PLANNING REPORT

Architectural Review Board

RIVERVIEW VILLAGE CONCEPT PLAN and DEMOLITION, 23-131CP and 23-132DEMO

23-131 CP/23-132 DEMO | RIVERVIEW VILLAGE
CONCEPT PLAN AND DEMOLITION REQUESTS

45 N. Riverview Street - Proposed

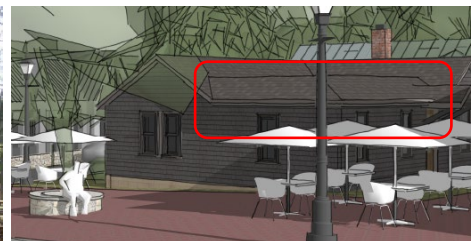
The applicant is proposing to renovate the house and keep its footprint intact. The front enclosure would be replaced with a new one, including more appropriate windows and wood posts. The roof is proposed to be replaced with a new one of a similar character, and the house is proposed to be painted a dark green color.

Staff recommends the removal of the aluminum siding and the restoration of the original siding. If space needs can be met, Staff also recommends the complete removal of the enclosed porch and its replacement with an open one consistent with the original. The applicant has expressed willingness to consider these recommendations. Final details will be addressed at the PDP stage.

53 N. Riverview St – Proposed Porch

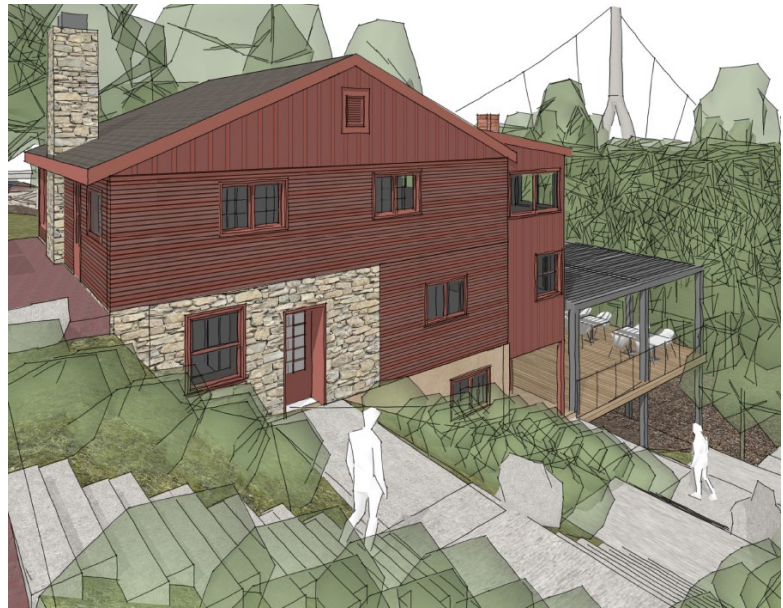
In addition, the applicant is proposing to remove the low porch ceiling and to open the porch gable while introducing Craftsman-style details. The house would be painted a warmer color.

This house was proposed to be demolished during the Informal Review process due to its poor condition and low ceilings. The alterations now proposed by the applicant would enable its preservation as part of the village. Staff is supportive of the changes, and will continue to work with the applicant on the details with the goal of refining them by the PDP stage.
